SUBJECT: REVISION OF MAPLHGR FIGURES (TAC NO. 68324)

RE: PEACH BOTTOM ATOMIC POWER STATION, UNIT NO. 2

AMENDMENT TO FACILITY OPERATING LICENSE

Amendment No. 139  
License No. DPR-44

MAXIMUM AVERAGE PLANAR LINEAR HEAT GENERATION RATE (MAPLHGR) VERSUS AVERAGE PLANAR EXPOSURE FOR FUEL TYPE BD319A (GE8X8EB)

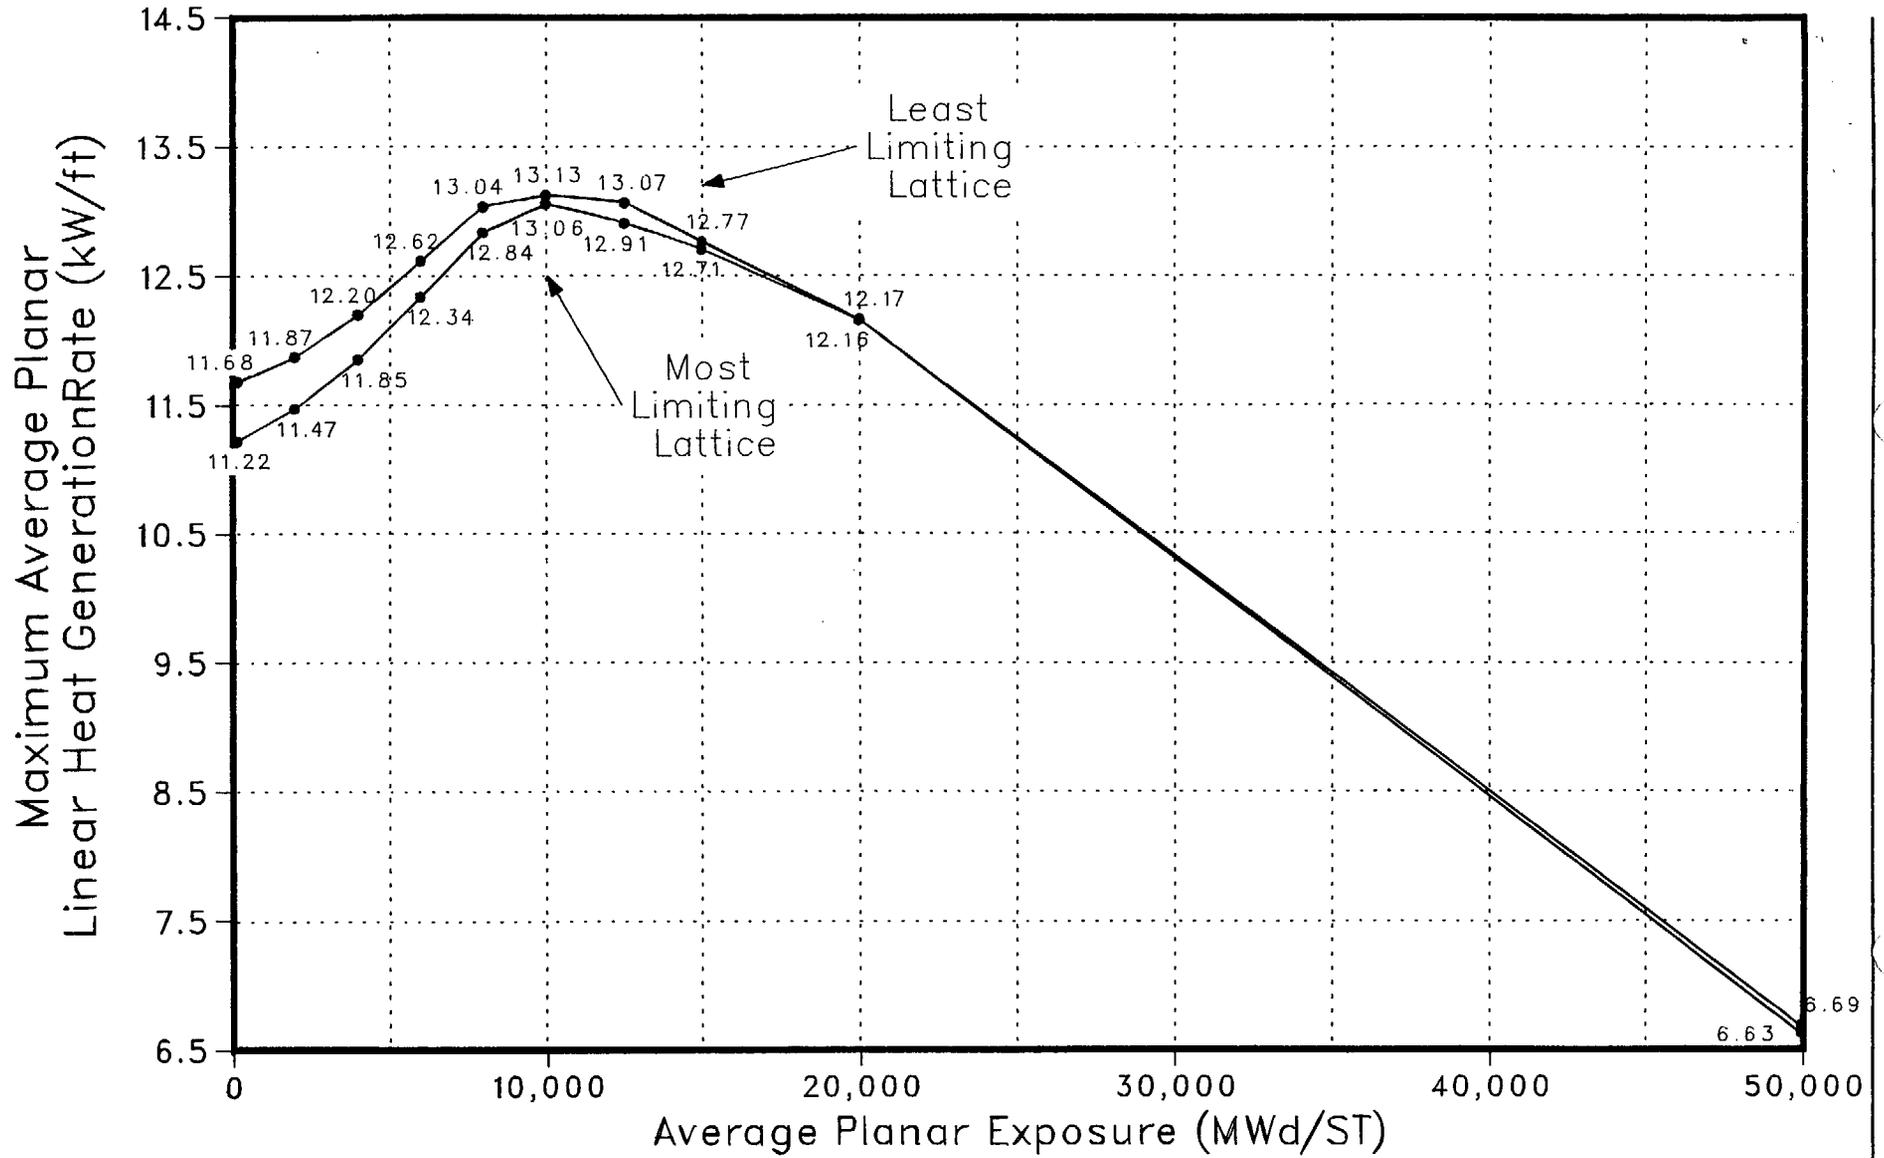
By letter dated April 21, 1988, Philadelphia Electric Company requested an amendment to Facility Operating License No. DPR-44 for the Peach Bottom Atomic Power Station, Unit No. 2. The proposed amendment would revise Figures 3.5.1.M and 3.5.1.N of the Technical Specifications to correct errors and to revise nomenclature. These figures show the most limiting and the least limiting values of the maximum average planar linear heat generation rate (MAPLHGR) for two of the fuel types (BD319A, BD321A) to be used in Unit 2 for cycle eight. These figures were issued with Amendment No. 123 to the Unit 2 operating license on September 11, 1987. The figures include curves showing the limiting MAPLHGR values versus exposure and also include printed numerical values at various points on the curves. The licensee states that the curve on Figure 3.5.1.M for BD319A fuel is incorrect; however, the printed values are correct. The licensee states that the curve on Figure 3.5.1.N for BD321A is incorrect. The printed values are correct except for the 12.17 value which is revised to a value of 12.18 as specified in the referenced General Electric report. The licensee proposes to replace these figures with ones which show the correct shape of the curve as well as the printed values. The corrections to the figures also include changes to reflect that the MAPLHGR values shown are for the most and least limiting lattices versus the most and least limiting MAPLHGR nomenclature as used previously.

Technical Specification changes related to the core reload to be used in fuel cycle no. 8 for Unit 2 were evaluated in the safety evaluation included with Amendment No. 123 which was issued on September 11, 1987. These changes included incorporation of the operating limits for all fuel types for cycle 8 operation, specifically the MAPLHGR limits for types BD319A, BD321A and LTA310 on pages 142l, 142m and 142n. These figures include curves as well as printed values of the limiting MAPLHGR versus exposure. In preparing the figures for fuel types BD319A and BD321A the licensee inadvertently used the same shaped curves as for fuel type LTA

310; however, the printed values were correct, with one minor exception, for each of the three fuel types. The licensee has assessed the safety significance of this error as follows:

The staff has reviewed the licensee's assessment and finds that the proposed correction of the Technical Specification figures is acceptable. The corrected figures will now include both printed values and curves that reflect the results of safety analyses that were previously reviewed and approved with the issuance of Amendment No. 123.
